DNJ ADDITION TO MOBILE SUBDIVISION

Engineering Comments: FINAL PLAT COMMENTS (should be addressed prior to submitting the FINAL PLAT for review and/or signature by the City Engineer):

DETAIL SITE PLAN

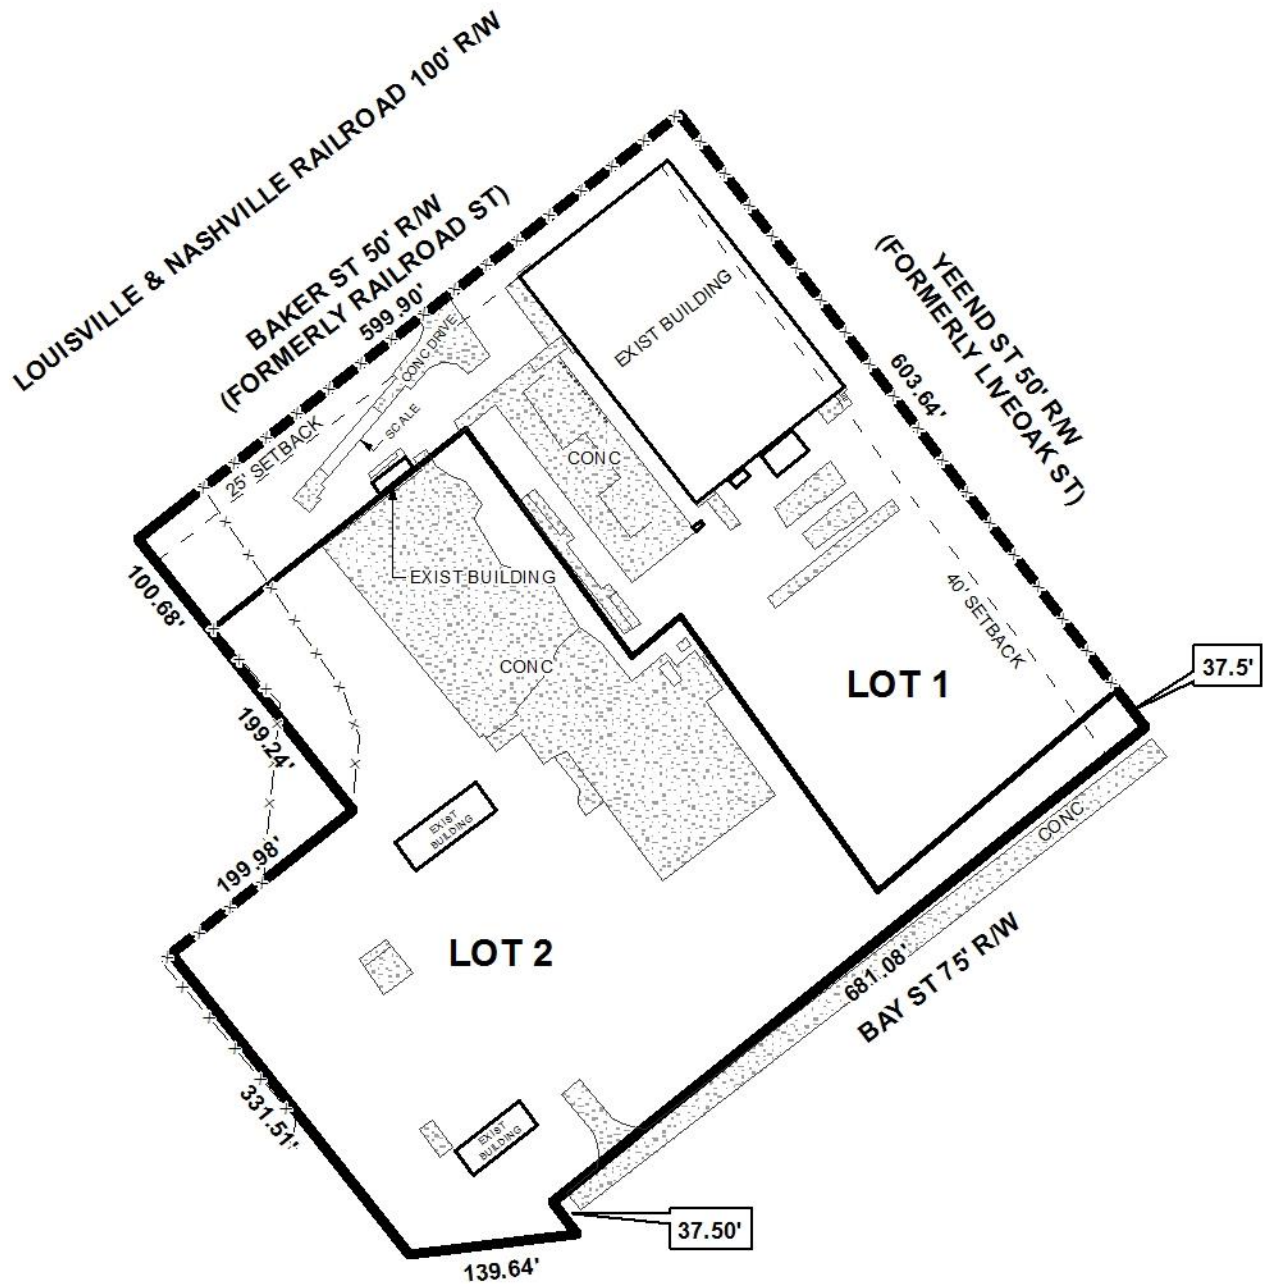
This application was heldover from the February 16th meeting at the applicant's request. A revised plat was submitted on February 14th and after staff reports were published for the February 16th meeting. The revised plat indicates multiple structures on both proposed lots with shared access between the two lots. Therefore, Planned Unit Development (PUD) approval would be required to allow such. As this is a condition of the previous approval recommendations, the PUD should be submitted and approved prior to signing the Final Plat for the Subdivision.

- 1) *retention of the 40' minimum building setback line along Yeend Street as measured 65' from the centerline of Yeend Street and the proposed Royal Street South major street;*

- 2) *retention of the 25' minimum building setback line along Baker Street as measured from the current right-of-way line;*
- 3) *retention of the 25' radius corner dedication at the intersection of Baker Street and Yeend Street;*

- 4) *placement of a note on the Final Plat stating that Lot 1 is limited to its existing curb cuts and Lot 2 is limited to one curb cut, with size, location and design to be approved by Traffic Engineering and conform to AASHTO standards;*

- 5) *retention of the lot size labels on each lot with their sizes in both square feet and acres, after any required corner radius dedication for Lot 1, or the furnishing of a table on the Final Plat providing the same information;*

- 6) *submission and approval of a full PUD for multiple buildings on each lot and shared access between the two lots prior to signing the Final Plat;*
